Subject: CLACKING NOISE WHEN STARTING TO MOVE VEHICLE WHILE STEERING WHEEL IS TURNED TO FULL LEFT POSITION	Bulletin No: 06-002/13
	Last Issued: 10/09/2013

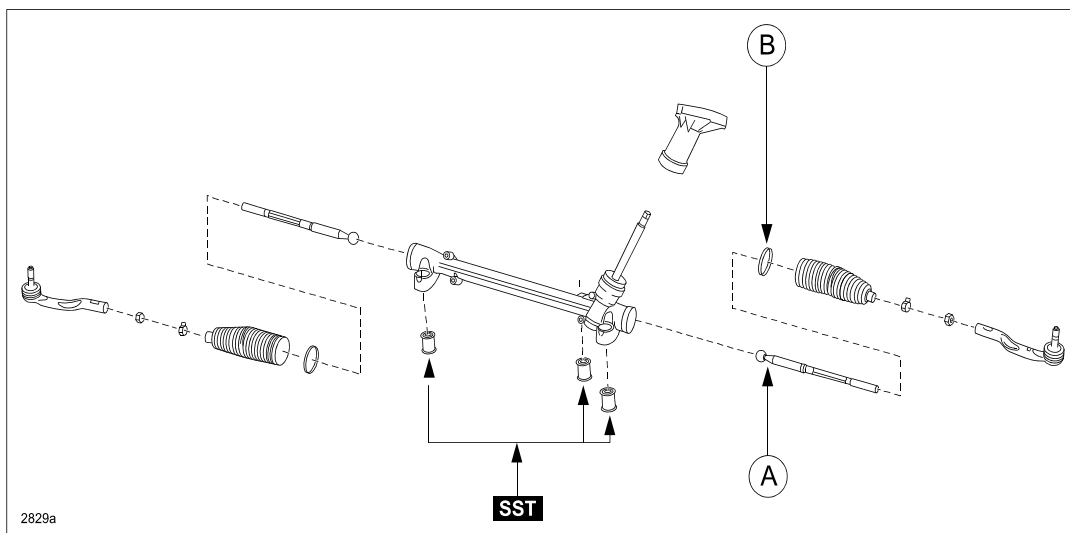
The noise is caused when the edge of the left side inner ball joint (A) gets stuck with the steering gear housing. The shape of the inner ball joint edge has been changed to eliminate this noise.

NOTE: Be sure to replace wire clamp (B), the joint bolt and both snap pins.

1. Verify the customer concern by turning the steering wheel full left, then start moving the vehicle.
2. Remove the steering gear and linkage according to the on-line instructions on MS3 or the Workshop Manual (section 06-13 STEERING GEAR AND LINKAGE REMOVAL) and replace the left inner ball joint (section 06-13 STEERING GEAR AND LINKAGE DISASSEMBLY).

Part Number	Description	Qty.	Notes
KD31-32-240A	Inner Ball Joint	1	(A) (See illustration)
BBM4-32-127	Wire Clamp	1	(B) (See illustration)
B455-32-099B	Joint Bolt	1	Replace joint bolt located between intermediate shaft and steering gear / linkage assembly.
T060-26-169A	Snap Pin	2	Replace snap pins for outer ball joint (tie rod end) on both sides.
